ADDENDUM #1

Bronson Court Site Upgrade Phase I-Reroofing
8 Pages including this cover sheet

Bronson Court Site Upgrade Project; Phase 01 – Re-Roofing

HUNT #2285-054

1 RAKE DETAIL AT ROOF TRANSITION
1/2" = 1'-0"

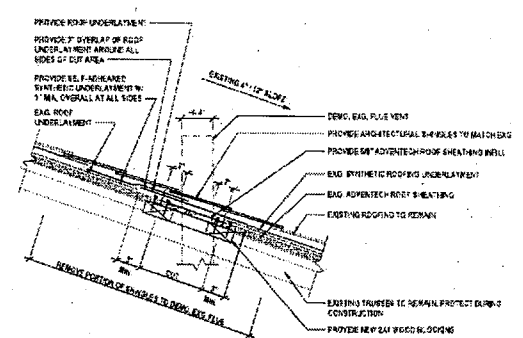
- ITEM AD1-3 Refer to A1.1 - ROOFING PLANS - BUILDINGS 1, 2 & 3**
ADD Add New Roof Work Note #8 that reads, "Provide cellular PVC roof rake. See detail 7A1.3 rake detail at roof transition."
- ITEM AD1-4 Refer to A1.2 - ROOFING PLANS - BUILDINGS 4, 5, 6, & 7**
ADD Add New Roof Work Note #8 that reads, "Provide cellular PVC roof rake. See detail 7A1.3 rake detail at roof transition."
- ITEM AD1-5 Refer to A1.3 - ROOF DETAILS**
REVISE Revised detail 2/A1.3 to clarify the extents of the ice and water shield.
- ITEM AD1-6 Refer to A1.3 - ROOF DETAILS**
REVISE Revised detail 3/A1.3 to remove and replace the exiting wood barge rafter/block with new.
- ITEM AD1-7 Refer to A1.3 - ROOF DETAILS**
ADD Added detail 7/A1.3 which clarifies the exterior wall flashing required at sidewall conditions.
